WSSC Ten Mile Creek Area Sewer Facility Study

Final Clarksburg - Ten Mile Creek Area Sewer Facility Study. The study area totals 980 acres within the Ten Mile Creek watershed, and lies within the 10 Mile Creek Limited Master Plan Amendment. The Facility study has been prepared for the Washington Suburban Sanitary Commission.

Figure 3-12 Alternative 12 - Gravity + 3 Pump Stations and Grinder Pump Systems (No Observation Drive)

Figure 1-1 Project Study Area in Seneca Creek Basin

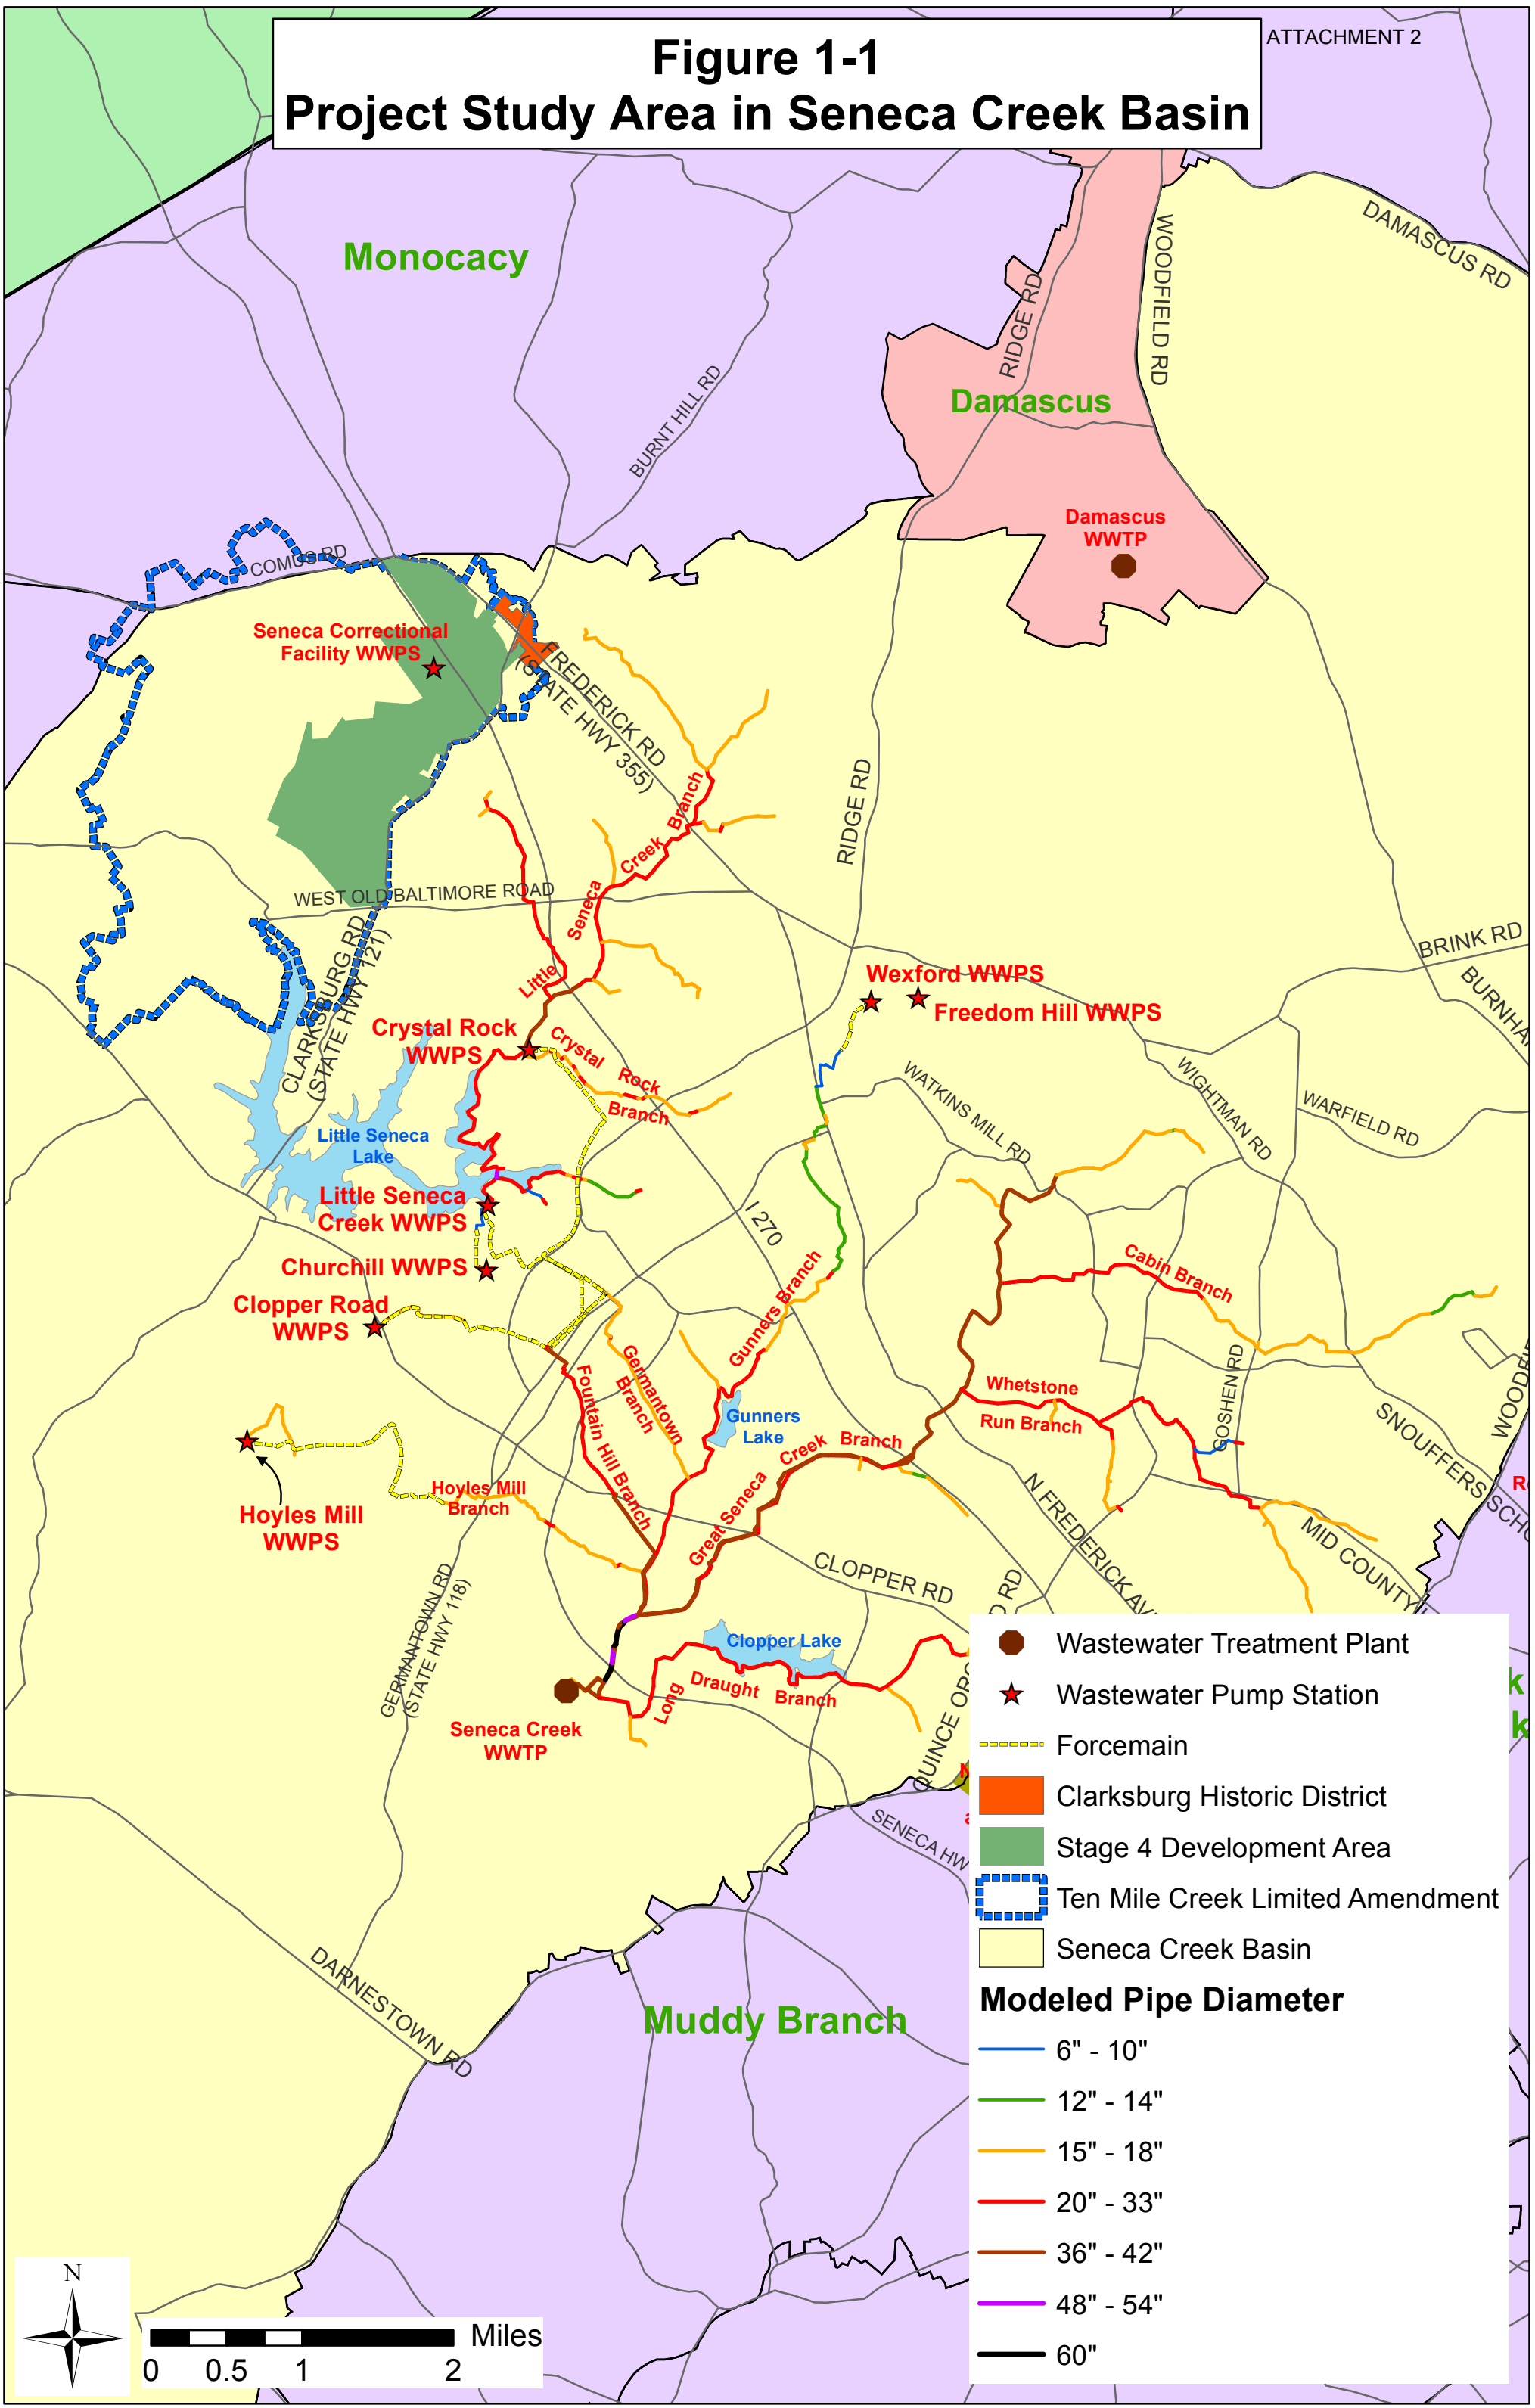
11	12/18/2015	Dave Lake (MCDEP)	<p>Figure 1-1:</p> <p><i>The Project Study Area need a companion map that identifies the TMC and tributaries as Figure 1-1 does for the downstream areas.</i></p>	An additional companion map (<i>New Fig 1-2</i>) is included in the Final Draft Report to address the comment.
12	12/18/2015	Dave Lake (MCDEP)	<p>Figure 1-2:</p> <ul style="list-style-type: none"> <i>This figure should include all of the Study Area and not be partially blocked by the table heading. It appears map legend for the Historic District Vicinity Properties is not accurately depicted.</i> <i>Legend colors and designations should align better.</i> 	Figure 1-3 (<i>Figure 1-2 in Working Draft Report</i>) of the Final Draft Report includes extent and legend modifications to address comment.
13	12/18/2015	Dave Lake (MCDEP)	<p>Figure 1-4:</p> <p><i>Cabin Branch is two different colors with no explanation.</i></p>	Figure 1-4 (of the Working Draft Report) has been deleted from the Final Draft Report since it relies on outdated information.
